HORSHAM DISTRICT COUNCIL CONSULTATION

TO:	Horsham District Council – Planning Dept
LOCATION:	Kingsmead Nursing Home Crawley Road Horsham West Sussex
DESCRIPTION:	Approval of details reserved by condition 11 to approved application DC/24/1010
REFERENCE:	DISC/25/0276
RECOMMENDATION:	Modification / More information
SUMMARY OF COMMENTS & RECOMMENDATION: 2nd set of comments in blue. The letter from DEP Landscape Architecture n response to our comments is noted and appreciated. We are satisfied the condition can now be discharged. Modification/more information is requested in order to recommend the discharge of Condition 11. Please see details below.	
MAIN COMMENTS: <u>Condition 14</u> <i>Notwithstanding the details shown on drawing 12586-FPCR-XX-XX-DR-L-0001 Rev P03 -General Arrangement Plan, the development hereby approved shall not be occupied until full details of all hard and soft landscaping works, including boundary treatments, have been submitted to and approved, in writing, by the Local Planning Authority. The details shall include plans and measures addressing the following:</i> a) <i>Details of all existing trees and planting to be retained, showing accordance with the approv

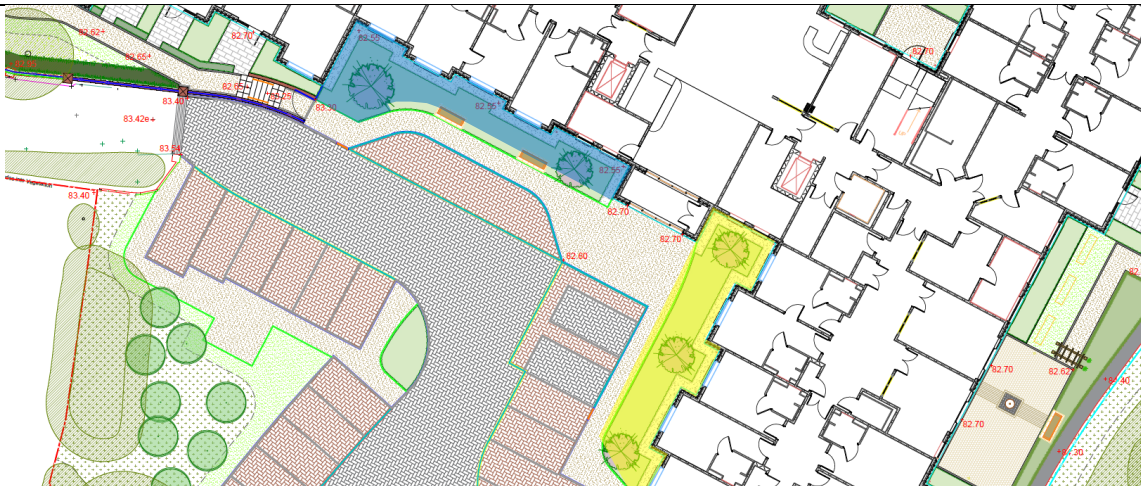
8. The area highlighted in blue [above] was approved as a bioretention area under DISC/25/0290 and therefore should be amended to reflect this. Please note that the plants proposed in this area should be suited to bioretention and provide both amenity and ecological benefits. [Reintroduced, with thanks. Closed](#)
